Motorola Solutions Technical Notification (MTN)

TITLE: Audio lost on (Gen1) GTR8000 channels during long calls

TECHNOLOGY: ASTRO 25 Trunking/Conventional

[192.168.1.1] CSS - ASTRO®25 Repeater Site Base Radio

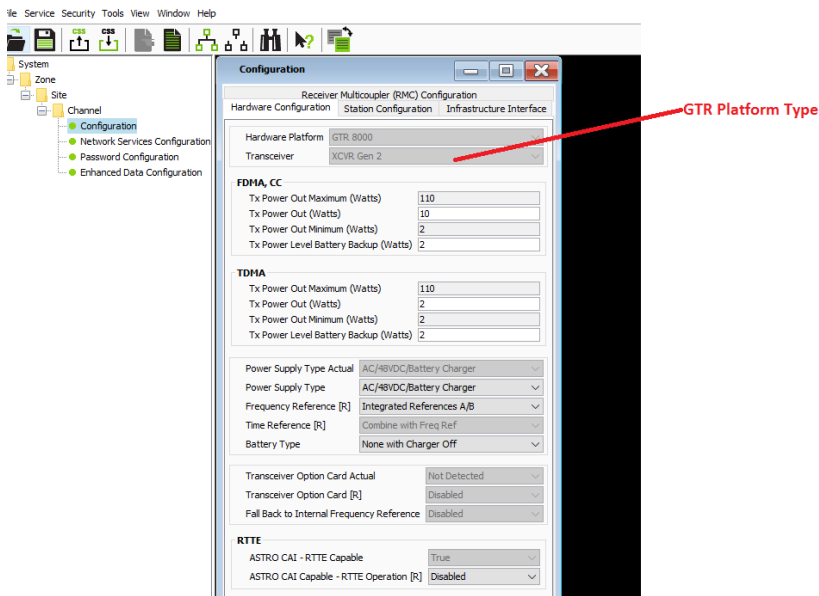
After reading the device with CSS, click on Configuration in the left navigation pane. In the Configuration window which appears, click on the Hardware Configuration tab. The second field ("Transceiver") will have the value "XCVR Gen 1" for GTR 8000 Gen1 equipment. See Figure below.
